Document Reviewed: Edgewood MD IHOP-Model.pdf Dated: 04/14/11

Comments From: Owner

Supplement to: Dwg Comments

MENS ROOM DIMENSION

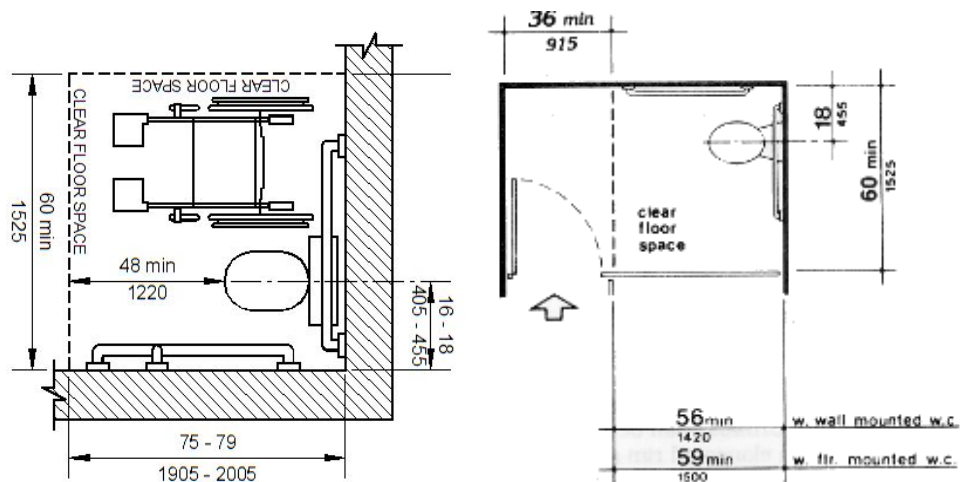
Please Confirm Design Fesibility: Rm Width of 75" is Drafted but a width of 69" Found in Photos. Refer to Attached Exhibit A

Photo of Existing Mens Room Showing Width based on Tile Count

FLAT ROOF STRUCTURE

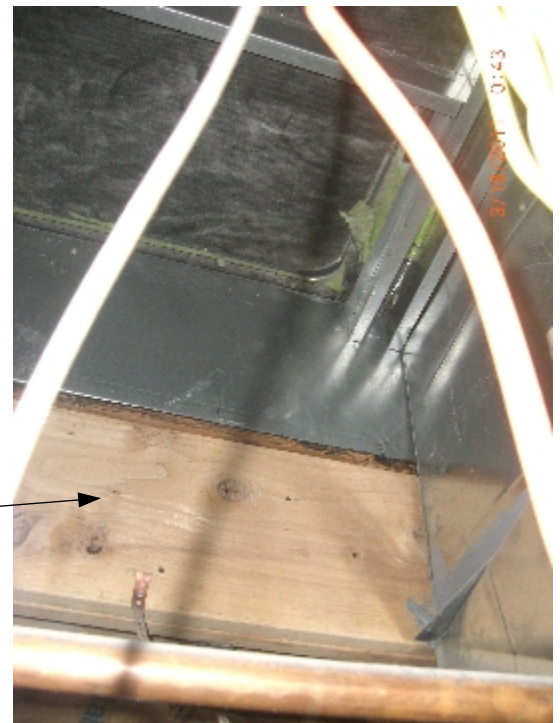
Please review Structural adequacy of Flat Roof for existing conditions. 2x10s @ 16oc. with no evidence of Struc. Col. at Main Beam. Refer to Exhibit B

Main Beam
5 -2x10 Lmd?

Main Beam w/ 2"
• Bearing at Exterior
wall

Flat Roof Detail:
Roof Finish on
• 3/4" Ply on
2x10 @ 16

1. See plan for Spans
2. Please confirm: No interior Wall Columns found in plans or in the field.
3. Please run Preliminary Struc Calcs to see if Flat roof can support optional Added loads.
